**Bid #018-006
Manchester High School
Exterior Stair Replacement**

ADDENDUM #1

May 7, 2018

STAIR PLAN

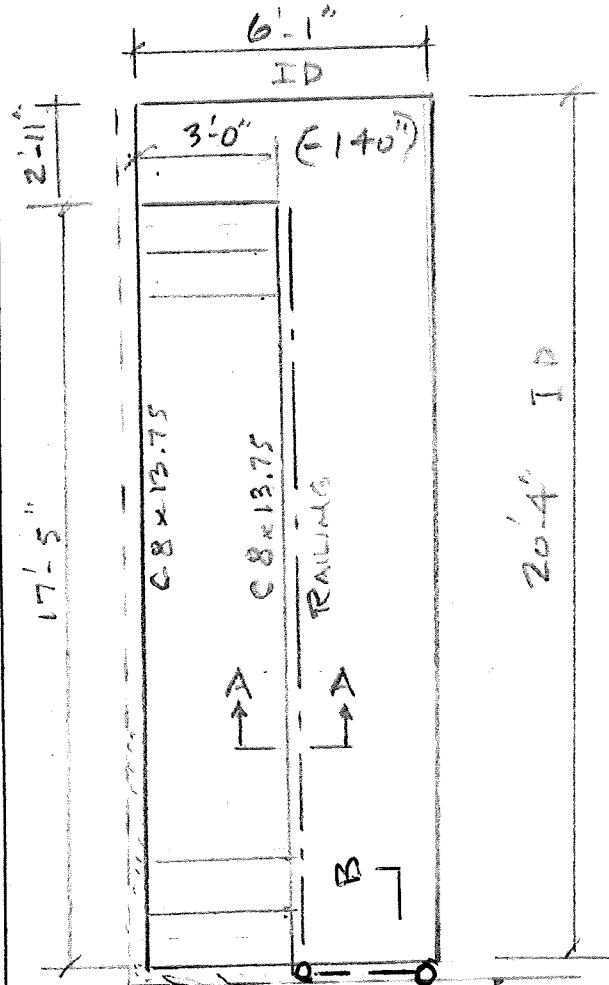
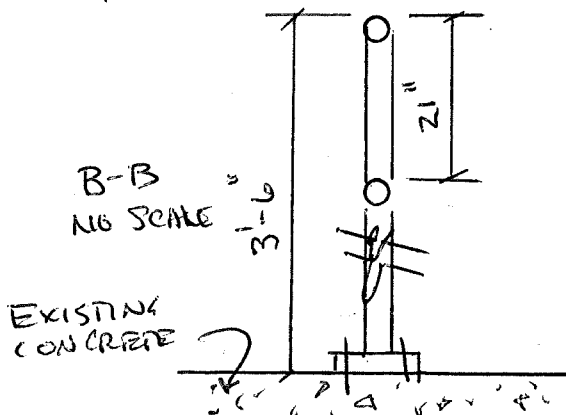
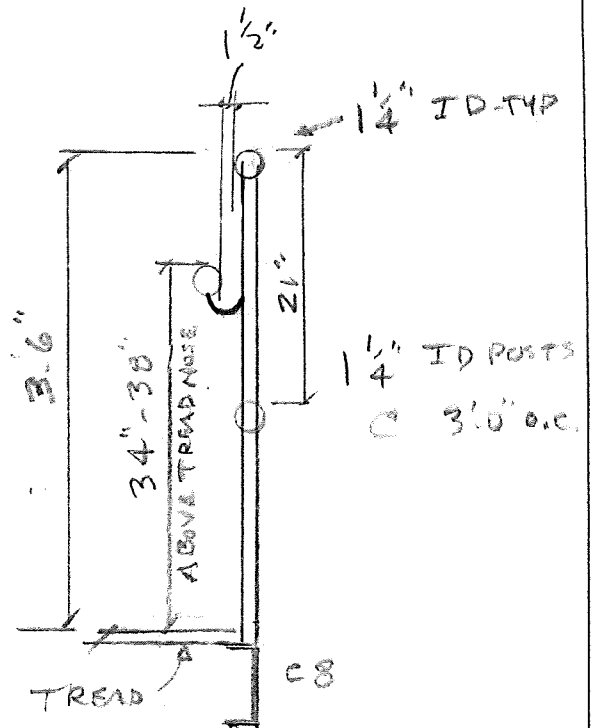
Railing is also to be installed at top of stair to close opening between fence and railing of stairway as shown on "stair plan" and section B-B of drawing entitled stairway.
